STAFF REPORT: 02/08/2024 REGULAR MEETING

APPLICATION NUMBER: HDC2024-00184

ADDRESS: 2491 LONGFELLOW

SCOPE: ALTER DWELLING (WORK COMPLETED WITHOUT APPROVAL), REMOVE TREE, INSTALL PARKING PAD AND FENCE

Fig 1, by Applicant: Proposed installation of the gravel pad and walkway, fence, and tree removal.

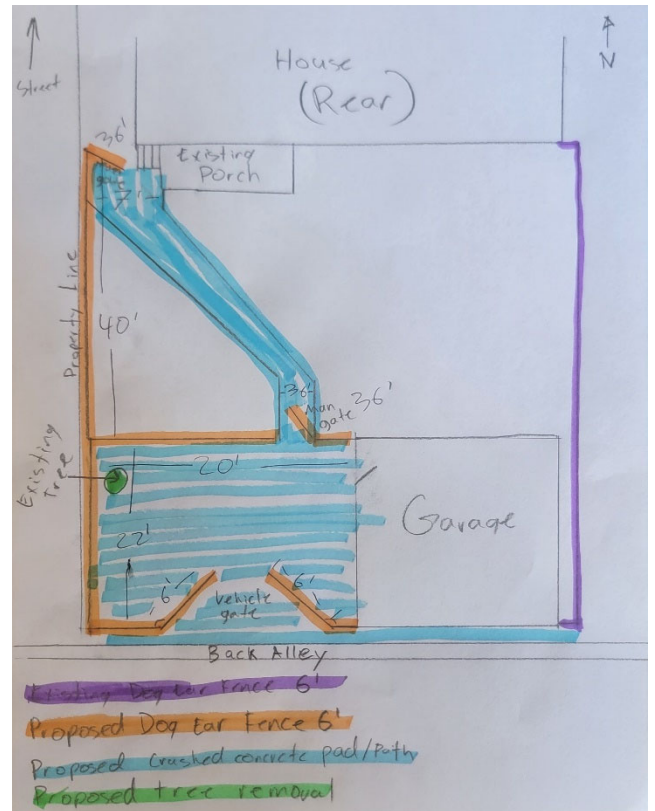
- Staff finds that the proposed gravel parking area and walking pathway are appropriate.
- Staff has the opinion that the proposed 6’ wood panel fence along the rear property line and inside the backyard are appropriate as they provide continuity to existing fence conditions and follow the HDC guidelines. Staff received clarification from the applicant’s contractor that the reason for waiting one year is allow the treated wood to age before being stained.

- The applicant provides HDC staff with a planting plan that offers at least one shade tree on the property to replace the removed tree.
- The applicant provides HDC staff with a paint or solid stain color for the fence.

Site Photo 4, by Staff April 19, 2024: (North) front elevation showing detail of thick, vinyl coil stock around brick mold and seam, and color tinted transom, proposed

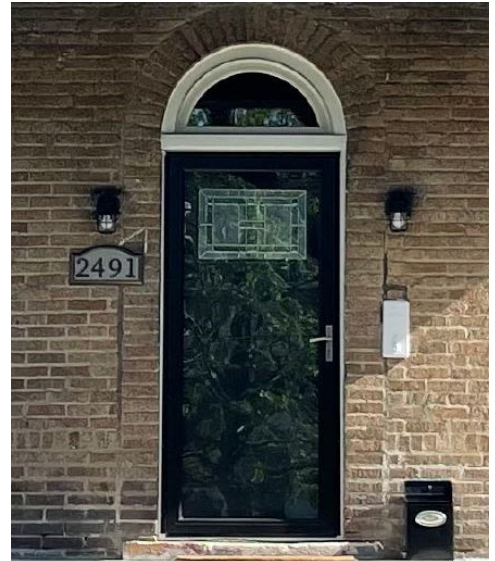
- In addition to a material change from wood to vinyl, the configuration and operation of the windows was also changed. For example, the dormer double-hung windows were replaced with slider windows. Coil stock is observed around most of the windows so it is not known if the original brick mould is still present. These newly installed windows have several features that are not appropriate:

- the surrounding coil covering the brickmould is large and gives the windows a chunky appearance and with the arched transoms, larger seems are found around the perimeter,

- the meeting rails in the double hung windows do not meet,

- the dimensions of the header and base of the window do not match the original wood windows,
- the between-the-glass grids lose dimensionality of the original divided light and do not match the original placement of the window's 8/1 versus 8/8 divided locations.
- The radial patterns of the true divided light original transoms are lost.
- Although the glass block basement windows did not strictly follow the HDC guidelines by recessing the glass block into the window opening that was once occupied by the historic location of the wood windows, staff has the opinion that the installation at these rear and side basement locations is appropriate.
